**Entergy
Operations**

SUBJECT: Arkansas Nuclear One - Units 1 and 2
Docket Nos. 50-313 and 50-368
License Nos. DPR-51 and NPF-6
Response to Station Blackout
Safety Evaluation Report
(TAC Nos. 68508 and 68509)

Simplified Single Line Diagram for Station Blackout

FIGURE 1

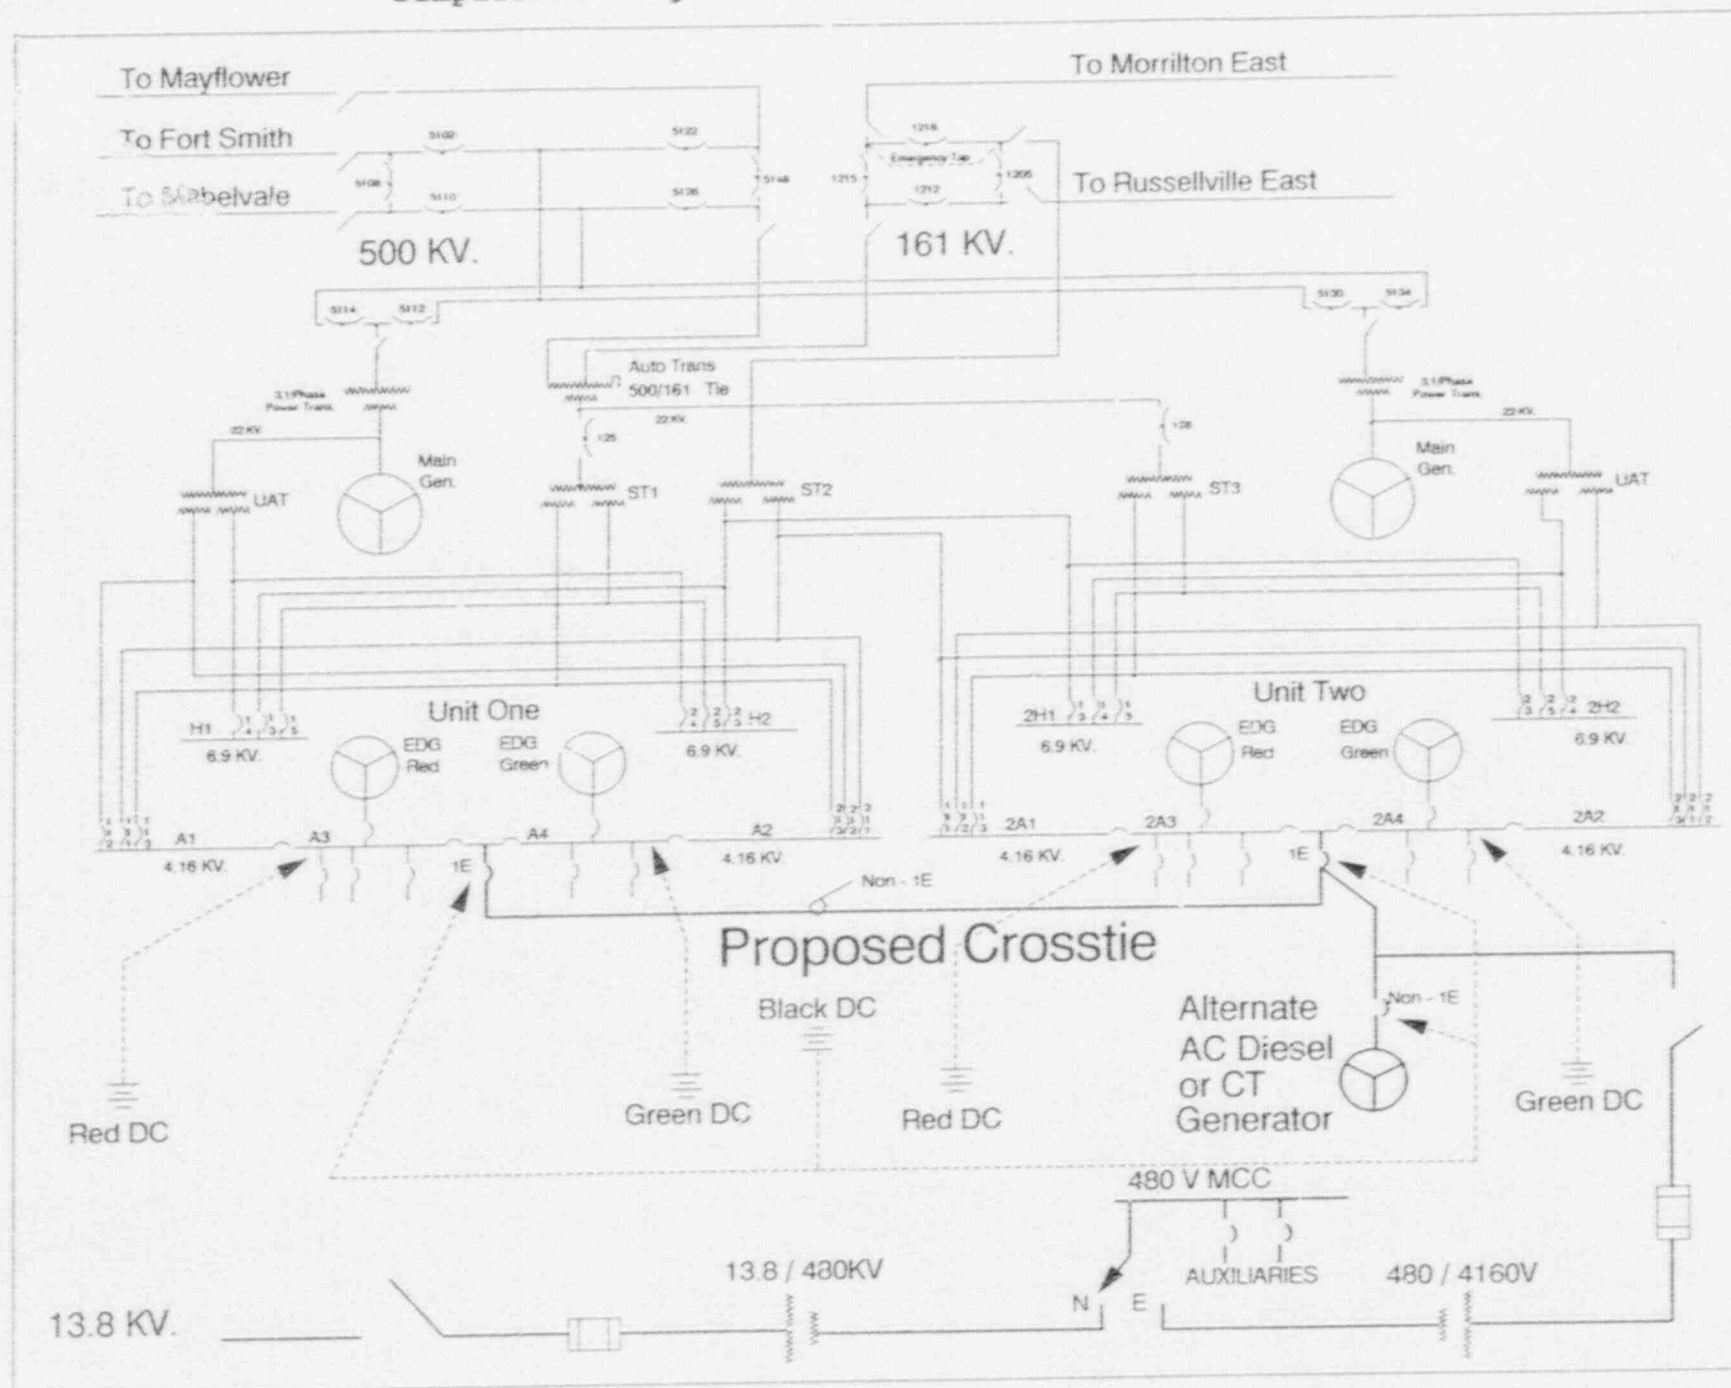
The purpose of this submittal is to provide a revised response to the SBO Rule for ANO-1 & 2. Details of this response are provided in Attachment 1. To address the NRC's concerns with our previous submittals Entergy Operations proposes to install an independent AAC power source capable of providing electrical power under blackout conditions to the affected unit.

The AAC power source that will be utilized at ANO-1 & 2 will meet the criteria specified in Appendix B to NUMARC 87-00. The AAC power source will consist of an independent diesel or combustion turbine generator, complete with an air start system, and a cable network which will enable it to access any of the four safety buses in ANO-1 & 2 without any necessary actions outside of the Control Room. The source will be available within 10 minutes of the onset of the SBO event (i.e., within 10 minutes after the operators have procedurally determined that a SBO event has occurred) and will have sufficient capacity and capability to operate the necessary systems to bring the unit to a safe shutdown condition and maintain that condition for the duration of the event. The AAC power source will be "full size", meaning that it will be capable of supplying the license basis loss of offsite power (LOOP) loads of any one of the four safety buses. Figure 1 provides a simplified one-line diagram of this AAC power source.

The modifications required to utilize the AAC power source (see Figure 1) are:

1. Cabling between each unit's safety buses and the AAC power source.
2. ANO-1 & 2 switchgear modifications to accommodate connection to the AAC power source.
3. Installation of the AAC power source and ancillary systems, including construction of the AAC power source building. This building will be constructed in conformance with the Uniform Building Code (UBC) requirements.
